Southern California Edison Company

Subject: Docket No. 50-206
Seismic Analyses
San Onofre Nuclear Generating Station
Unit 1

REVIEW OF NRC PROPOSED ANALYSIS
METHODOLOGY AND CRITERIA

PSEUDO ORIGINAL PLANT DESIGN CRITERIA AND METHODOLOGY

FIGURE 1 (FSA FIGURE 9.2)

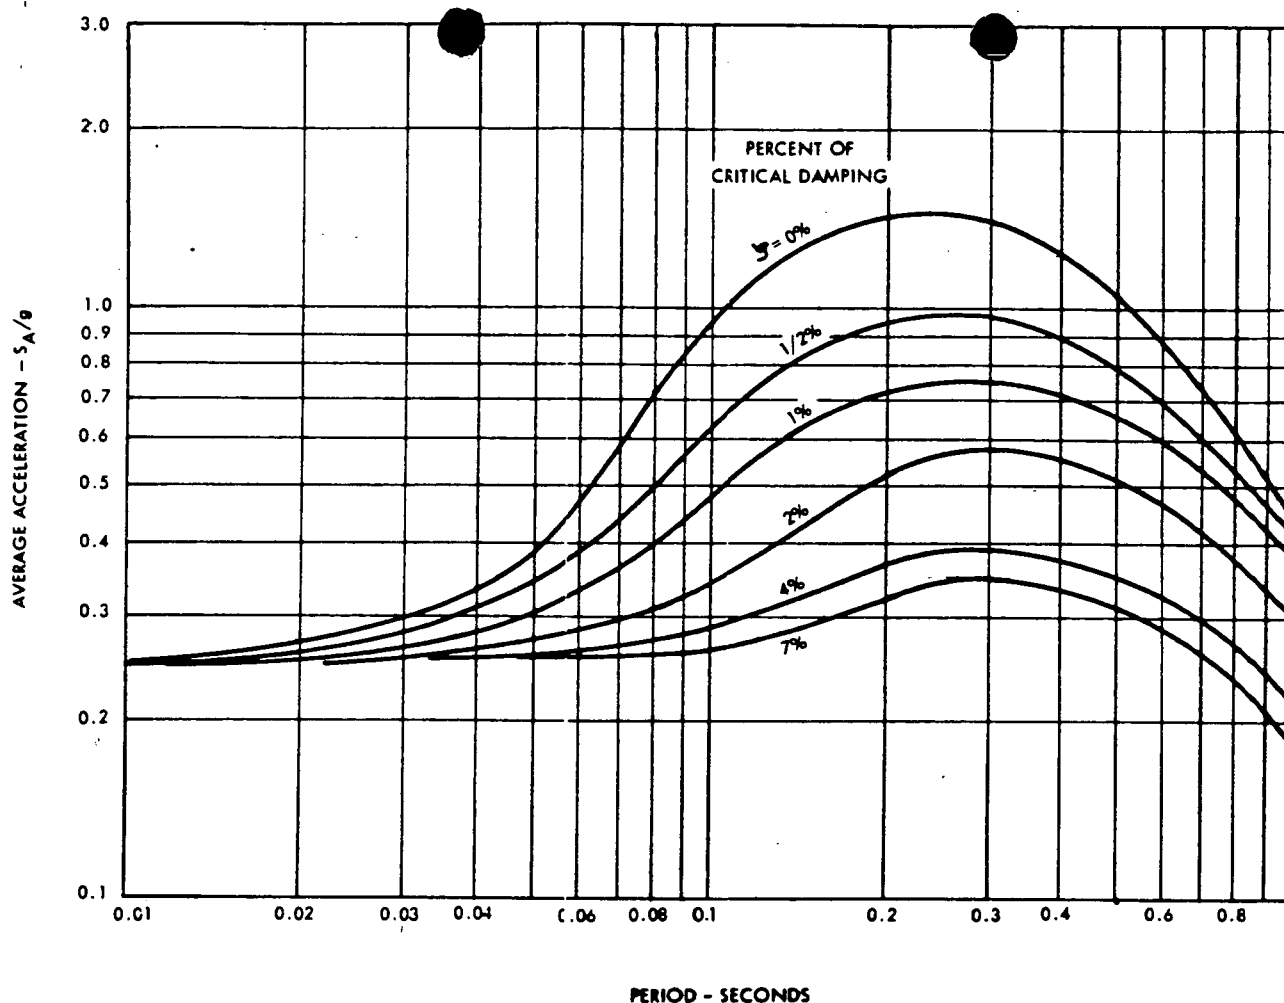
- o Design Spectrum: Figure 1, which is Figure 9.2 of the SONGS 1 FSA, shows a log-log plot of the acceleration response spectra normalized to a maximum ground acceleration of 0.25 g for various percentages of critical damping. The input data for these curves were developed by Dr. G. W. Housner. These curves cover periods from 0.01 to 1.0 second and damping factors of one-half percent to seven percent. The horizontal component of the ground acceleration was taken directly from the curves of Figure 1 and the vertical component was taken as two-thirds of this value.

Since the peak acceleration for 1/2% damping, as shown in Figure 1, is only one g, piping stress allowables shall govern the analysis of piping systems in which valves are included and where no purchase specification or vendor specifications are available that specify lower accelerations.

Transverse Earthquake

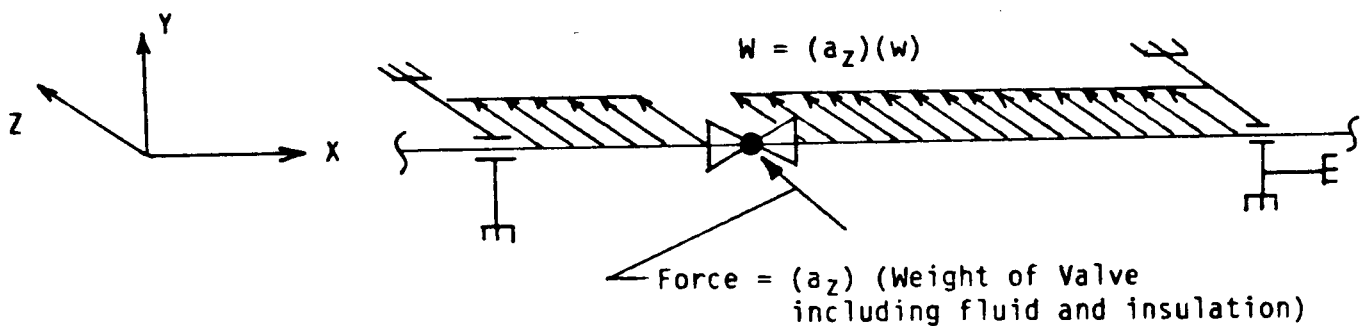
- Step 1 Calculate natural frequency, f_z , of seismic span, ($L_1 + L_2$), taking into consideration the concentrated mass (modeled along the center line of the pipe).
- Step 2 Read the acceleration corresponding to the natural frequency of that segment in the Z-direction, f_z , from the 0.25 normalized response curve for 1/2% of critical damping.
- Step 3 Multiply the span acceleration by the span uniform load and the concentrated mass.

Vertical Direction Earthquake

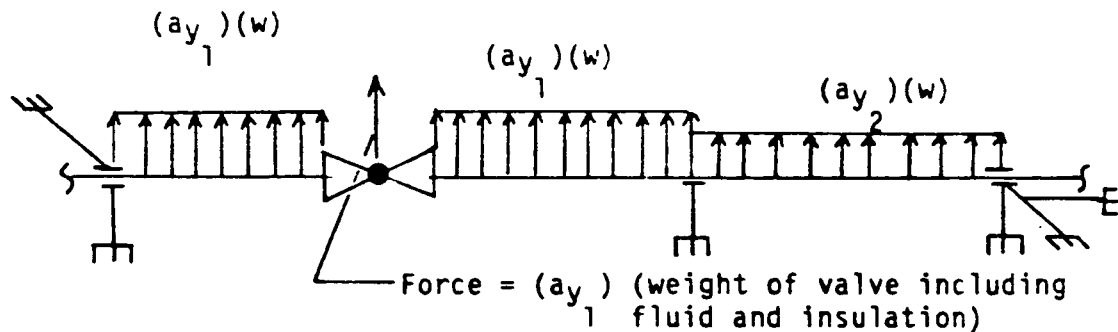
- Step 1 Calculate the natural frequency, f_y , of each seismic span, L_1 and L_2 , taking into consideration the concentrated mass (modeled along the center line of the pipe) for span L_1 .
- Step 2 Read the acceleration corresponding to the natural frequency for each span, L_1 and L_2 in Y-direction from the 0.25 normalized response curve for 1/2% of critical damping. Multiply the accelerations by 2/3 (to obtain vertical component of earthquake).
- Step 3 Multiply the span acceleration by the span uniform load and the concentrated mass.
